Proposed Standard Plan Changes.

July2, 2015

Standard Plans Change Request

JUNCTION BOX/PULLBOX DETAIL
POWER OR FUTURE CONDUCTORS
N.T.S.

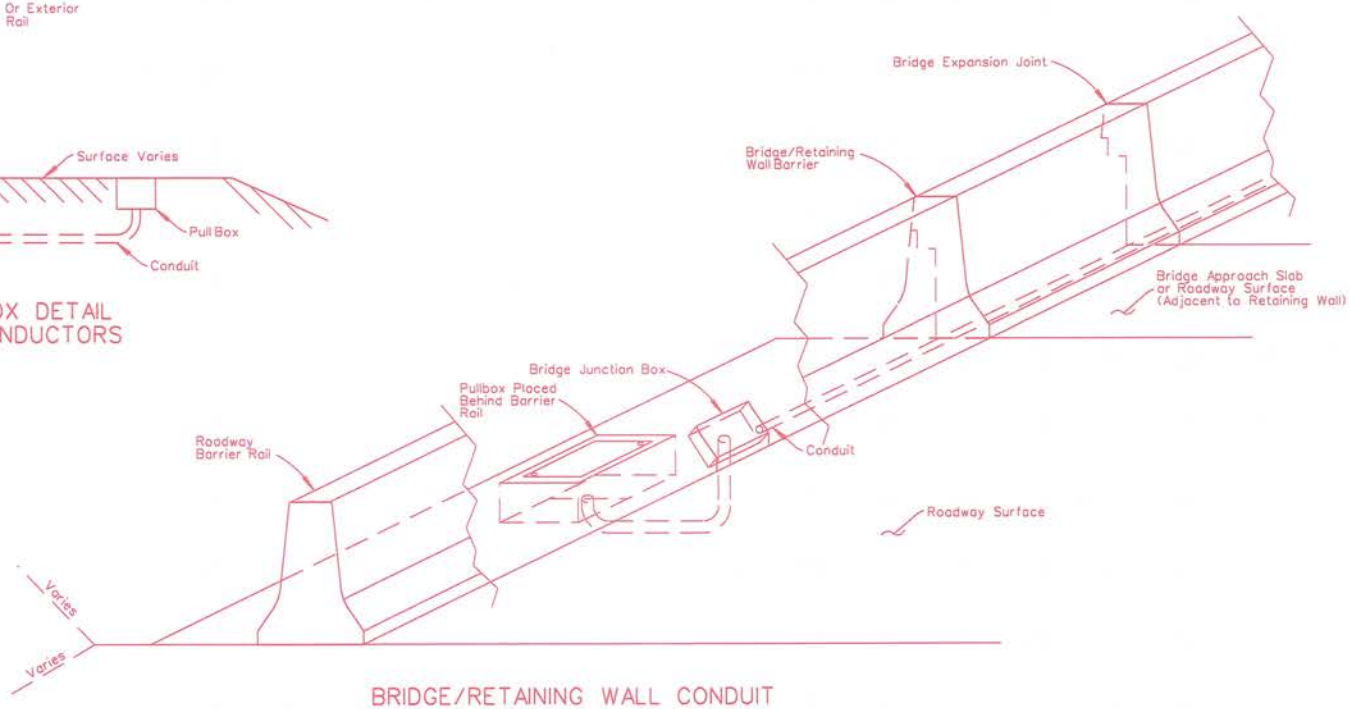
Description of requested modification or correction: UPDATE BRIDGE / BARRIER RAIL JUNCTION BOX DETAIL

ROADSIDE SIGNS
SQUARE METAL POSTS

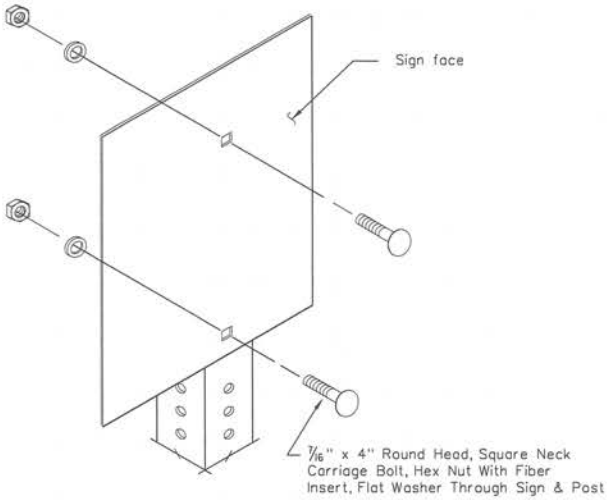
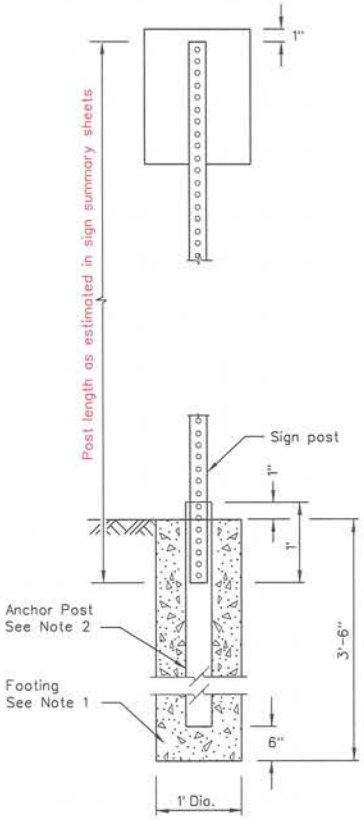
1. Note 2 - Delete "post" from end of note
2. Note 3 - Delete
3. Change note for post length. Substitute the word "estimated" instead of noted
4. Remove the note, "Sign Panel Bracing as required see standard plan T-31.1.4", arrow and symbols pertaining to the that note.
5. Remove "(Bolt head colored to match sign face)," from note for 1/16"x 4" round head, square neck carriage bolt

SINGLE POST

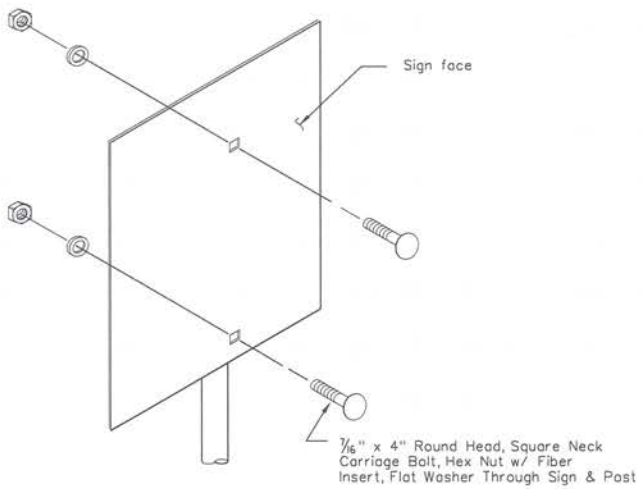
1. Note 1 – Delete "post" from end of note
2. Note 2 – Delete
3. Delete note "Sign hardware, bracing, vertical joints, vertical joint closure strip & stringers as required. See Standard Plan T-31.1.4"
4. Remove "(Bolt head colored to match sign face)," from note for 1/16"x 4" round head, square neck carriage bolt
5. Substitute "Estimated" for "Noted" in the three other notes pertaining to Post Lengths

ASSEMBLY ELEVATION VIEW

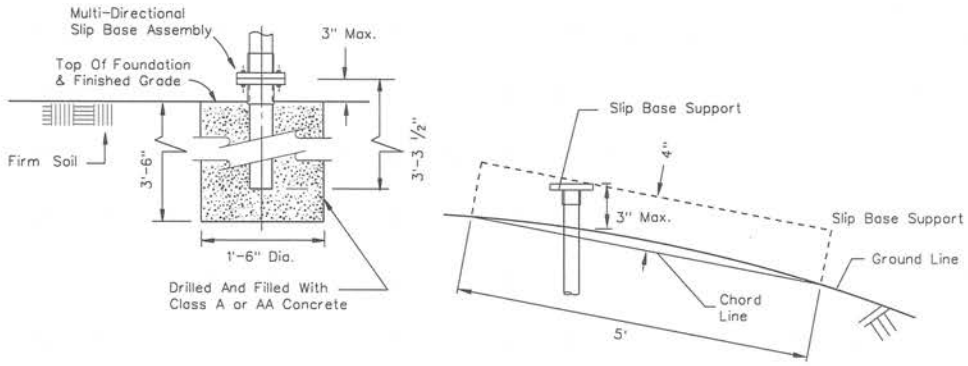
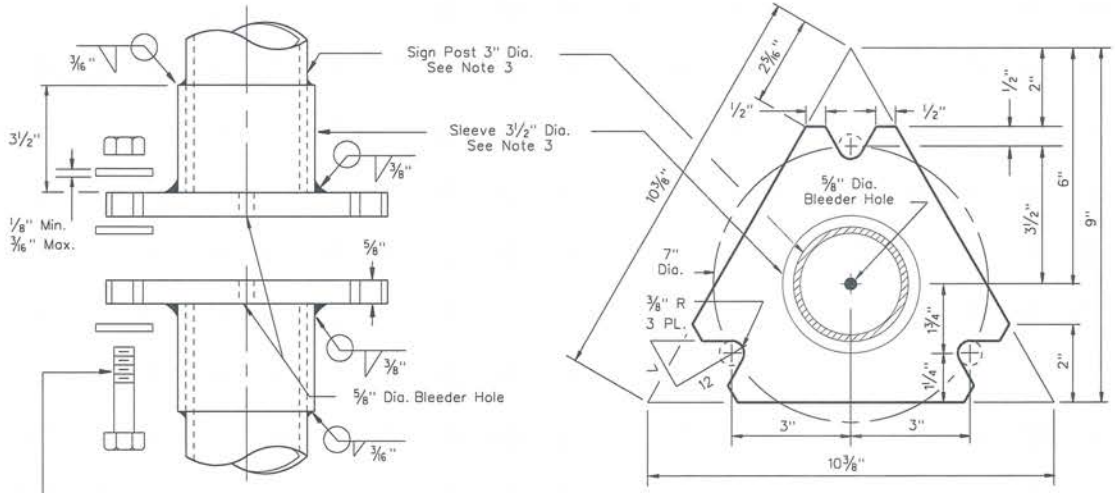
1. Note 4 – Delete
.....
.....
.....
.....
.....
.....
.....
.....
..... (Please attach supporting information).

ROADSIDE SIGNS
ROUND METAL POSTS
BRACED

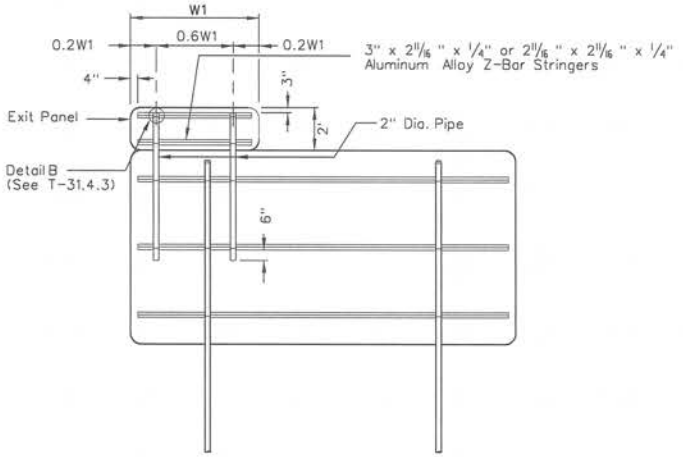
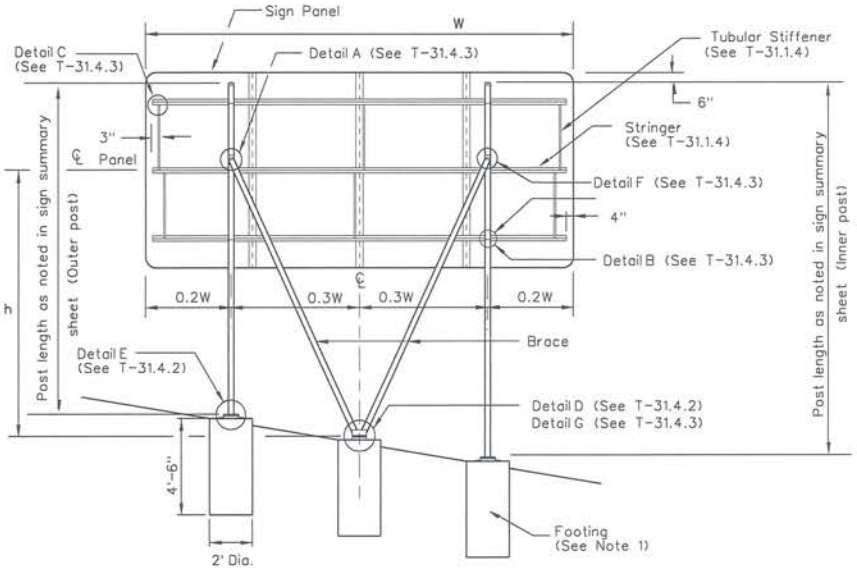
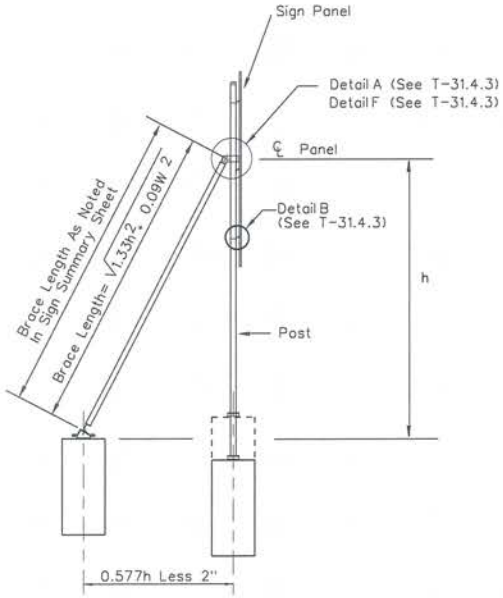
1. Note 2 – Delete the word "Post" at the end of this note.
2. Note 3 – Delete
   .....
   .....
   .....
   .....
   .....
   .....
   .....
   ..... (Please attach supporting information).

DETAIL G

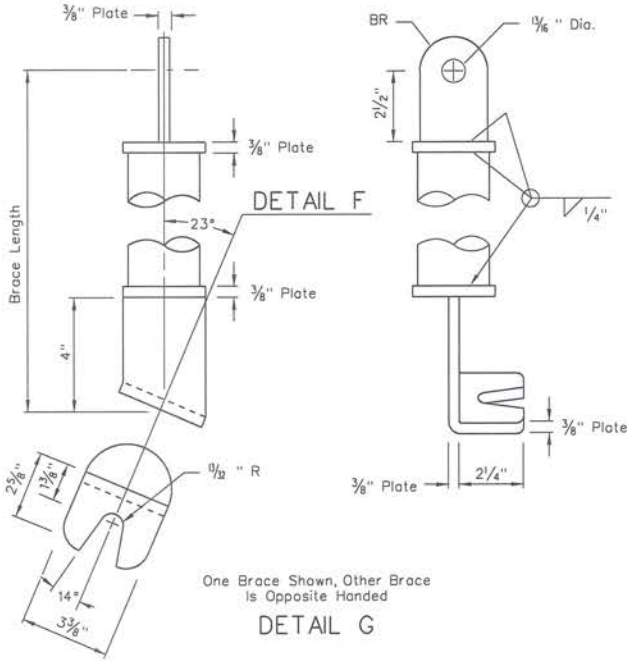
1. "Notes" - Delete
2. Delete Legend and Asterisk *

TYPICAL CONDUIT CONFIGURATION DETAIL
FOR TRANSFORMER CABINET INSTALLATION
NTS

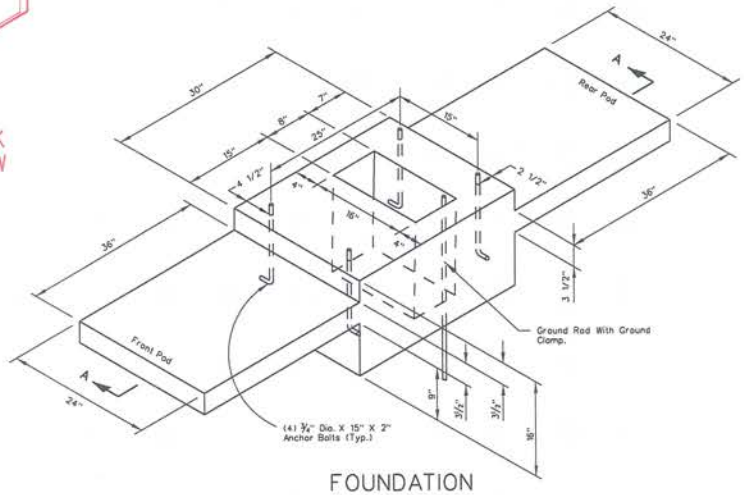
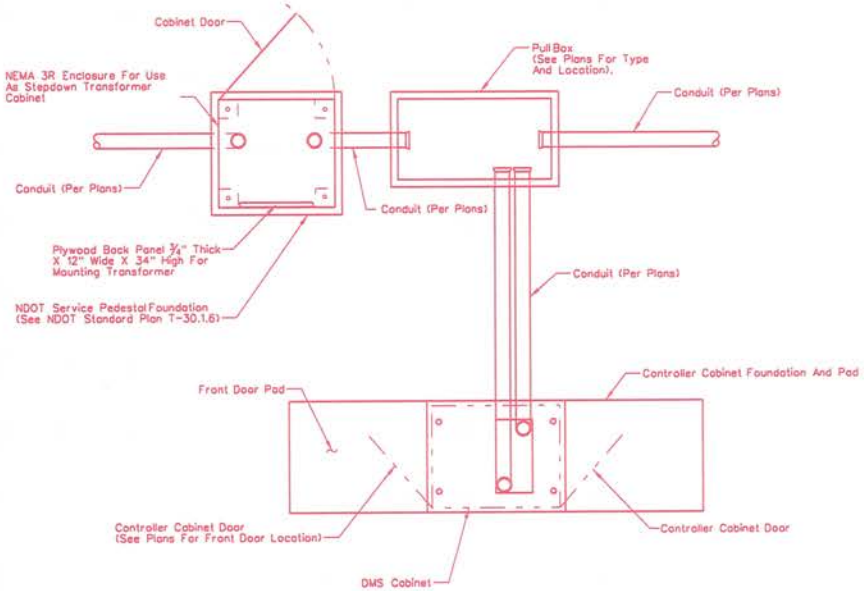
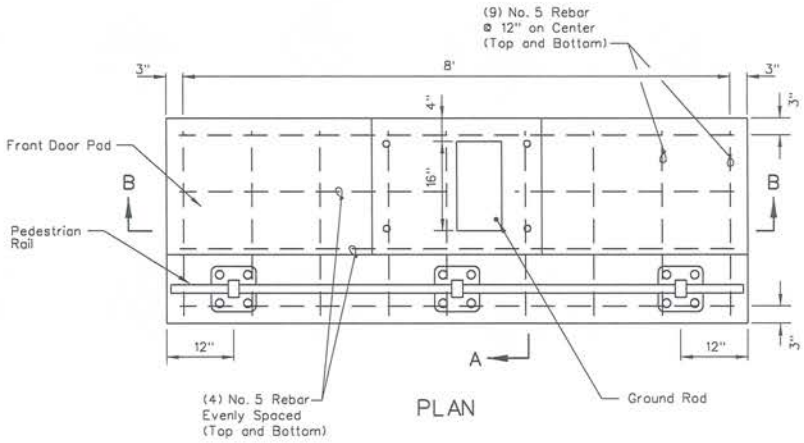
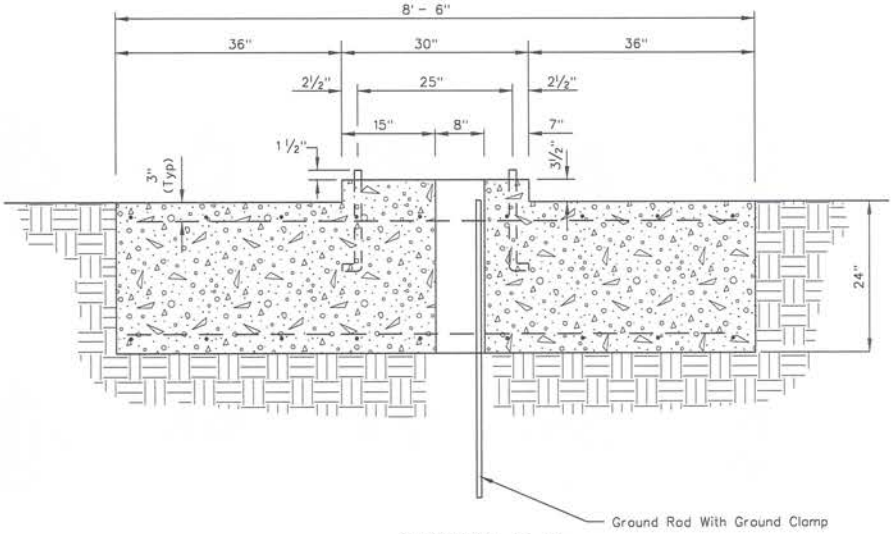
Description of requested modification or correction: MOVE STANDARD DETAIL TO T SHEETS RIGHT AFTER T-30.15 AND CHANGE NUMBERING TO "T" SHEETS INCLUDE DETAILS FROM ITS PROJECT AND INCLUDE ATTACHED CABINET SHEETS (SEE ATTACHED) (Please attach supporting information).

SECTION B-B
NTS

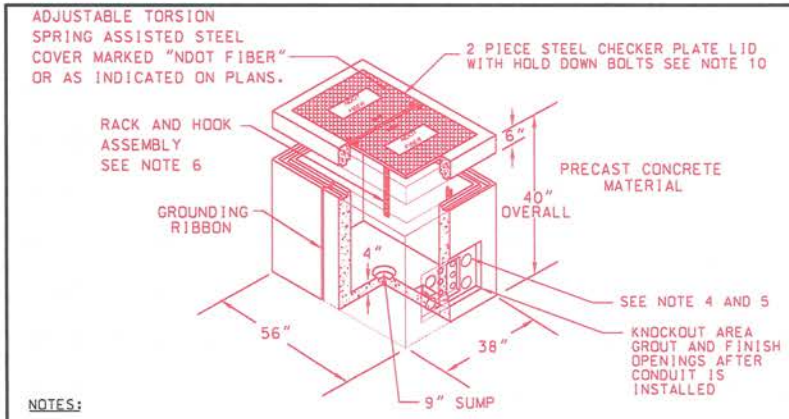
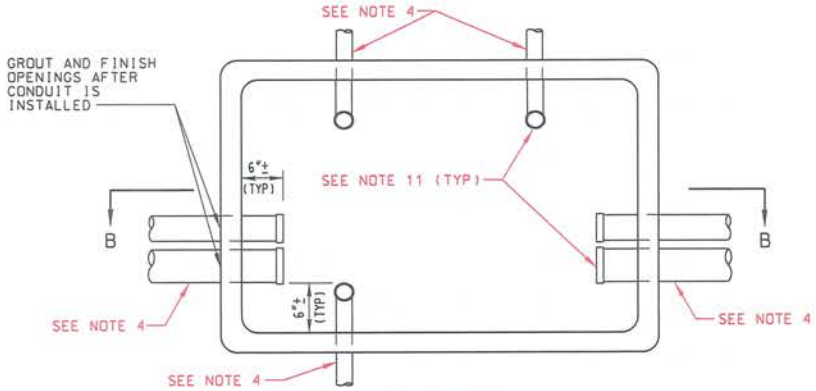
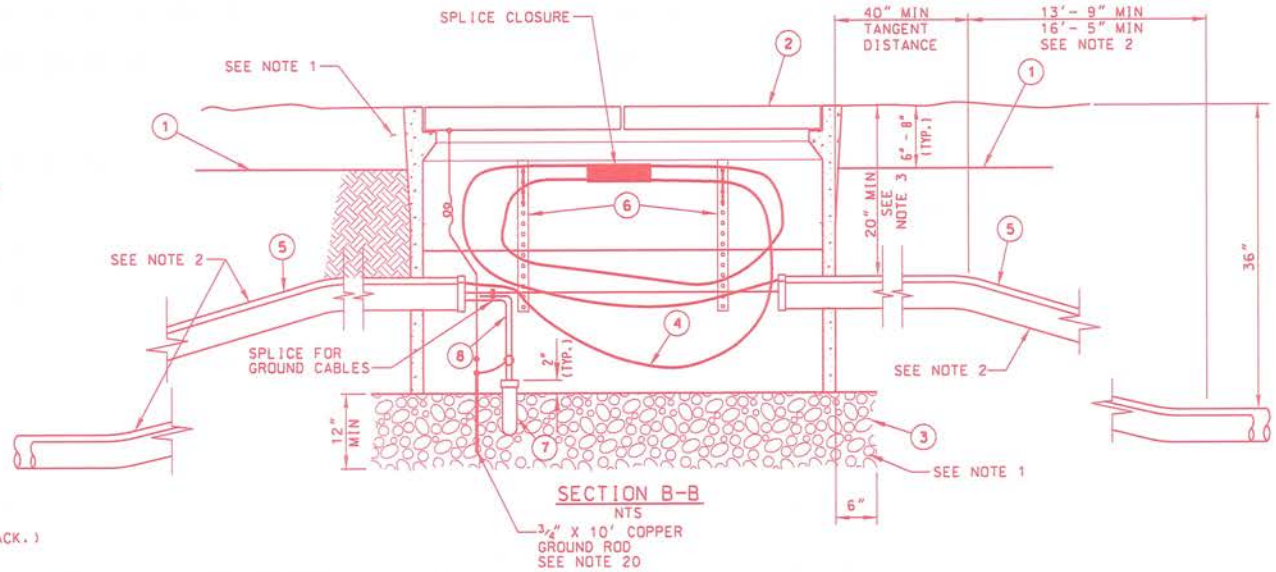
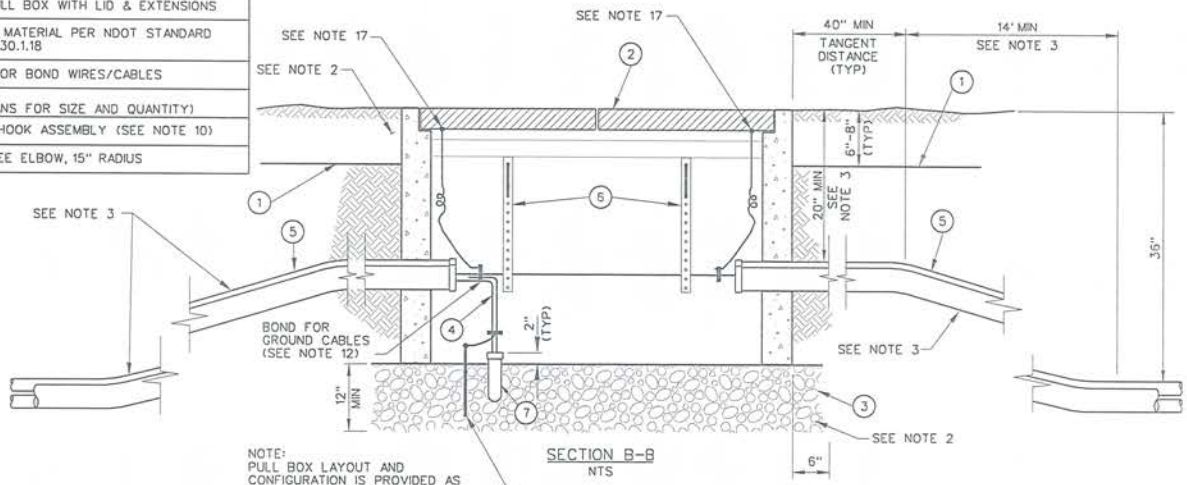
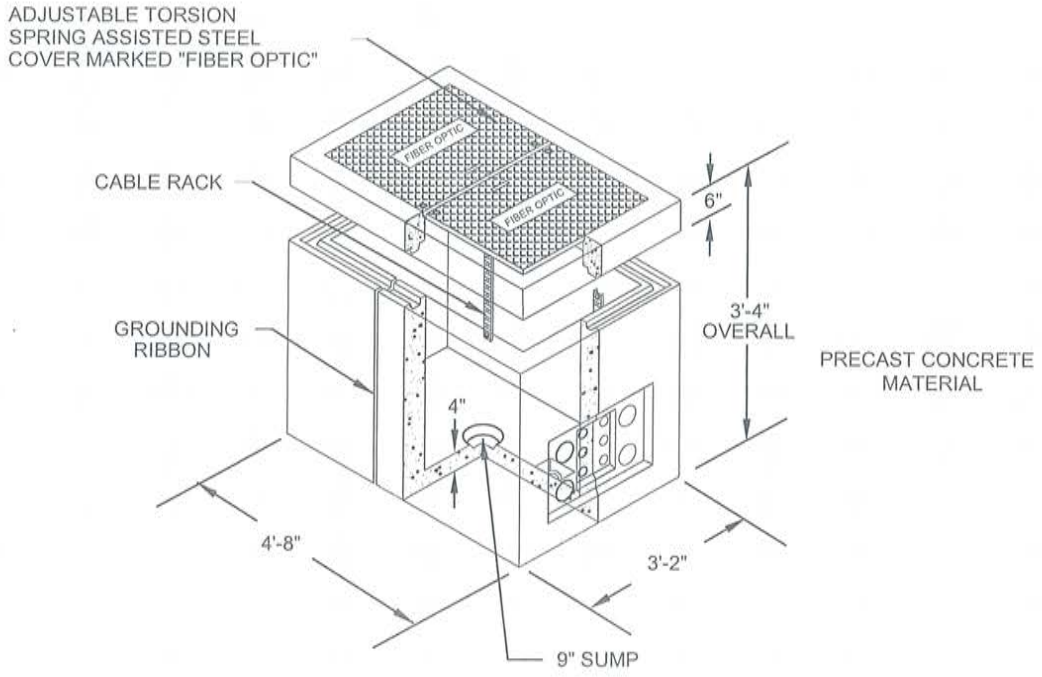
Description of requested modification or correction: MOVE NO. 9 PB MODIFIED DETAIL RIGHT AFTER T-30.1.18 AND UPDATE WITH THE ATTACHED DRAWINGS
